UNITED STATES PATENT AND TRADEMARK OFFICE

APPLICATION NO.	FILING DATE	FIRST NAMED INVENTOR	ATTORNEY DOCKET NO.	CONFIRMATION NO.
10/067,050	02/04/2002	Scott A. Leman	8350.1314-00	4929

Office Action Summary	Application No. 10/067,050	Applicant(s) LEMAN ET AL.	
	Examiner Zelalem Eshete	Art Unit 3748

DETAILED ACTION

FIG.4

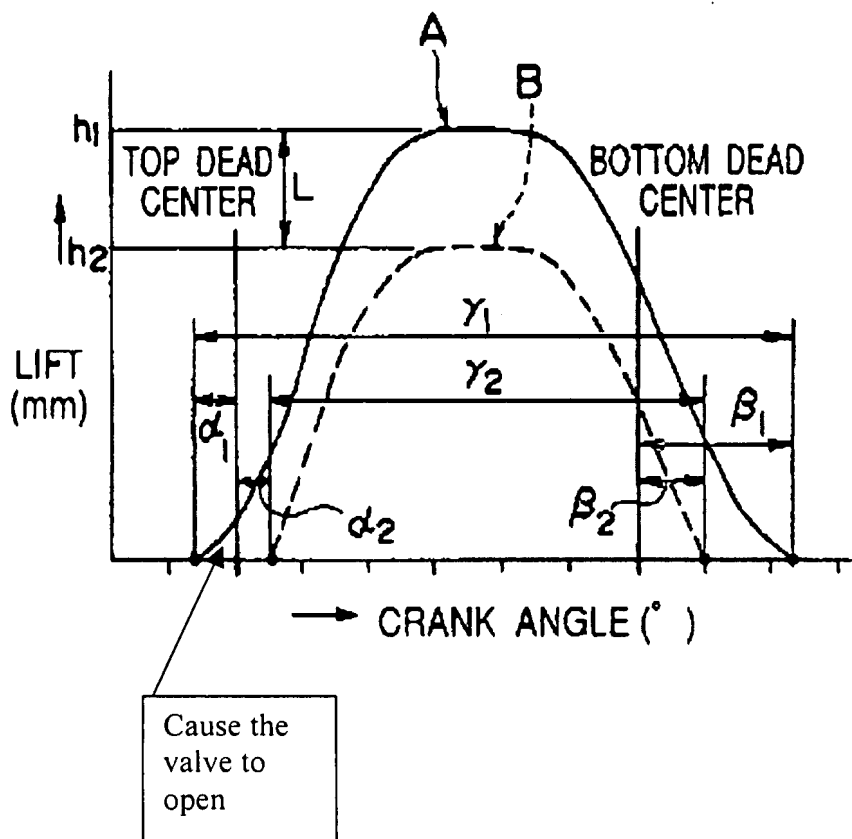
13. With respect to applicant's argument on pages 4,5: Kanzaki discloses the fluidically driven actuator cause the valve to open (see labeled figure 4 below).
